FCC Class II Permissive Change Application Letter

Product name : Wi-Fi 1T1R 11n + Bluetooth4.2 Combo Module

FCC ID: 2AT5W-O8723UE

Model No.: O8723UE

Location	Old PCB of FCC ID: 2AT5W-O8723UE	New PCB of FCC ID: 2AT5W-O8723UE
Mainboard

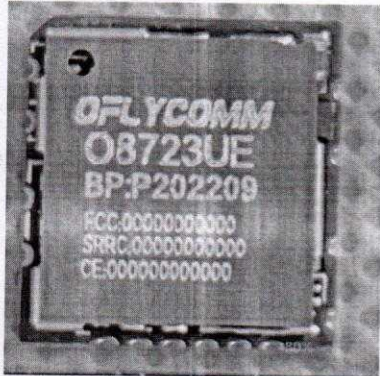
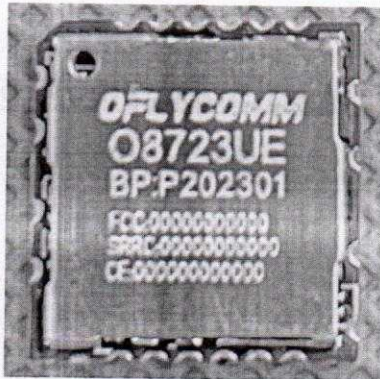
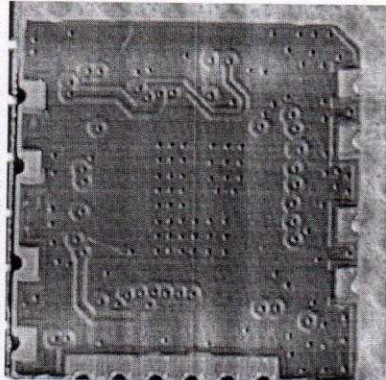
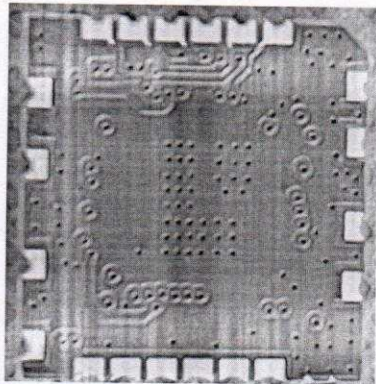
Change Contents: update the PCB as below:

The module opens the six pins at one end; Changes are made to the board layout for minor circuitry for non-transmitter portions; No change in radio parameters has occurred. The function of the 15-20 PIN of the module is turned on. See the circuit diagram and PCB LAYOUT for details; 15-20 PIN is designed to control wifi, Bluetooth and cpu control signals, 15pin has no function for other modules compatible design, 16pin wifi enable control, 17pin Bluetooth enable control, 18pin NC for compatible design. The 19pin cpu enables the wifi control signal, and the 20pin cpu enables the wifi control sign.
